I am appalled to discover only a week ago that the Nuclear Regulatory Commission is actually considering the Construction and Operation of an Independent Spent Fuel Storage Installation on the Reservation of the Skull Valley Band of Goshute Indians and the related transportation facility in Tooele County, Utah.

1.) I would like to quickly make some comments on the DEIS (NUREG-1714) but I must first ask for an extension of the public comment period, at least for 90 days, since I've only just found out about it.

'Prayer for Skull Valley'

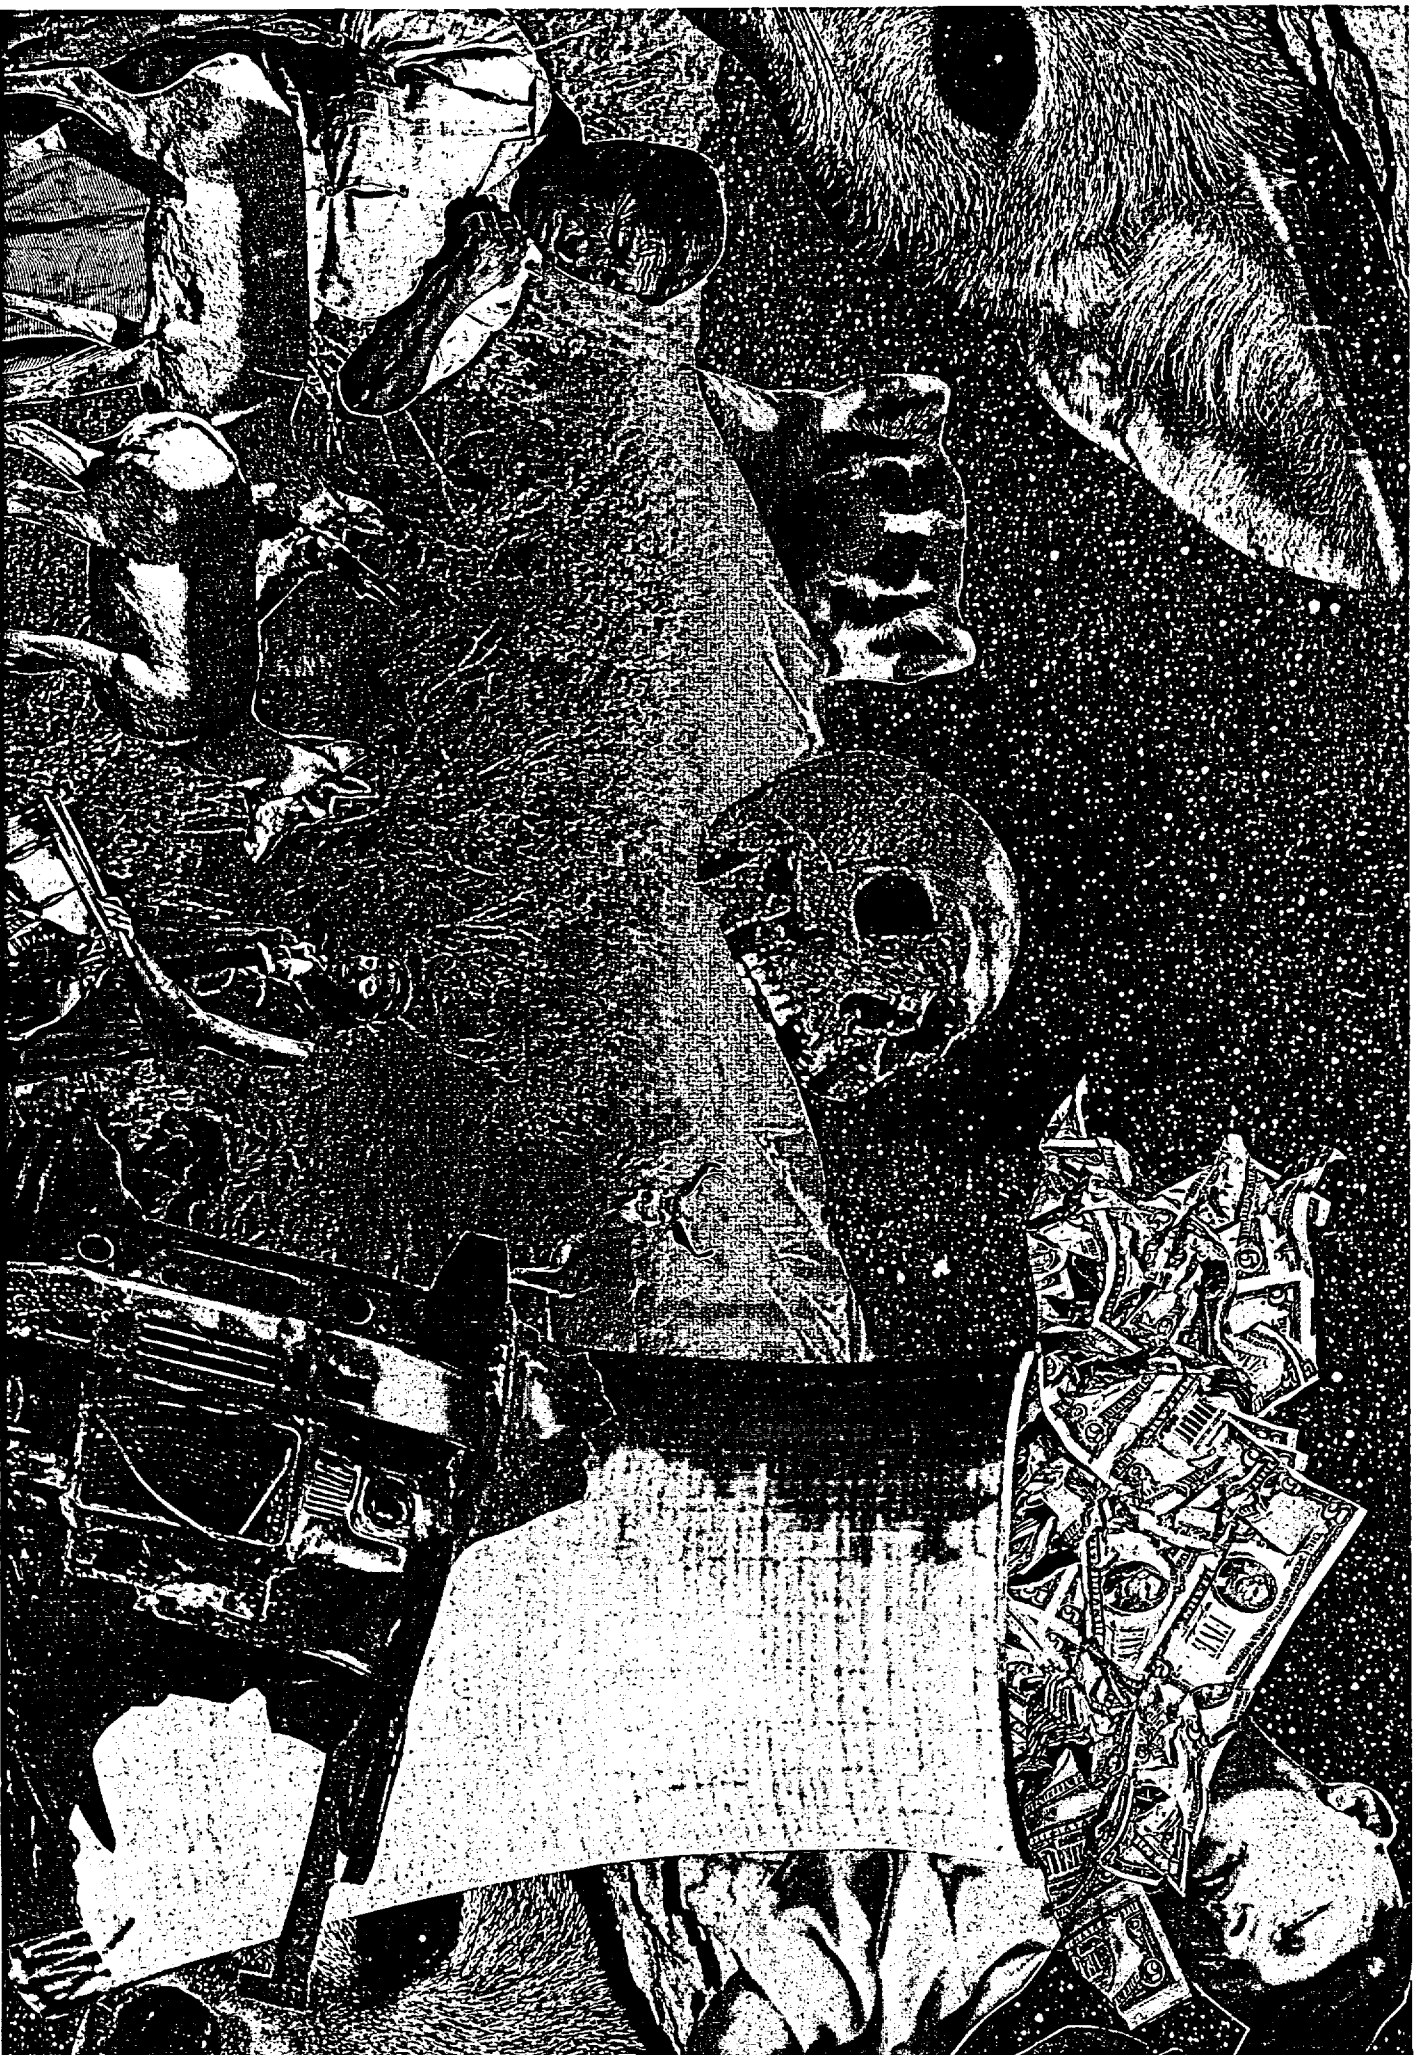
2.) I quickly put together a collage I want included as part of my comments—see enclosure collage called "Prayer for Skull Valley." I worked quickly, but many hours on this collage. I've included many images that are self-explanatory—creatures that live in the area, (they deserve a voice) The overturned hazardous waste truck, and many other images I will not explain, but it is obvious I oppose the shipments ADM03 of this waste and support the NO ACTION
